FIELD SERVICE BULLETIN

FSB Number: LVCCFSB2006-121
Author: Tony Bryan
Date: April 24, 2006
Total No. of Pages: 3
Subject: GSM PEBL U6 – Rear Housing Screw Torque
Phone Models: GSM PEBL U6
Level of Repair: 2

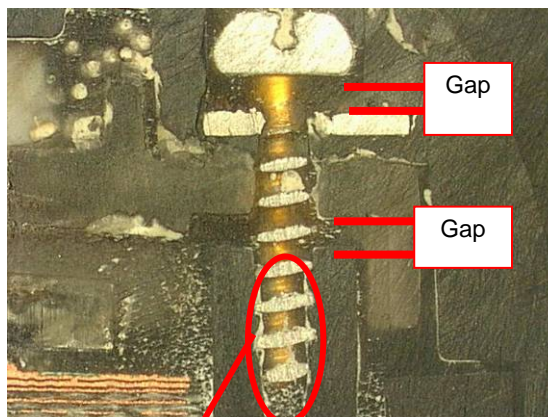
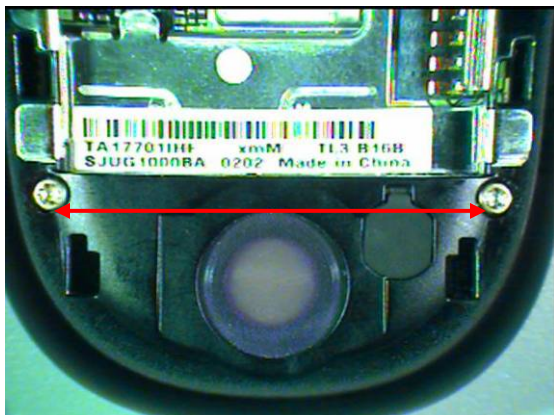
The issue occurred on the bottom two self-tapping R-Hsg Screws. The screw bosses were closely examined, confirming the screws were never driven in completely at factory assembly. After the screws were re-tightened to the proper settings, the failures could no longer be duplicated. See Images below.

Less than 4 threads engaged with F-Hsg boss.

The Factory Quality Team has investigated this issue and confirmed failure can occur in production on some torque drivers with torque measuring on the low end of spec. Original Torque Specification was 1.25 in-lbs (+/- 10%). In addition, the factory found that the speed setting of the driver (high speed is about 700 rpm and low speed is about 500 rpm) can affect the torque and result in a higher rate of occurrence.

A new torque study was completed by Factory and ME Team which has resulted in an increase in the Torque Specification for the R-Hsg Screws.

New Torque Specification Target: 1.33 in-lbs.

(Upper Tolerance 1.37 in-lbs. / Lower Tolerance 1.30 in-lbs.)
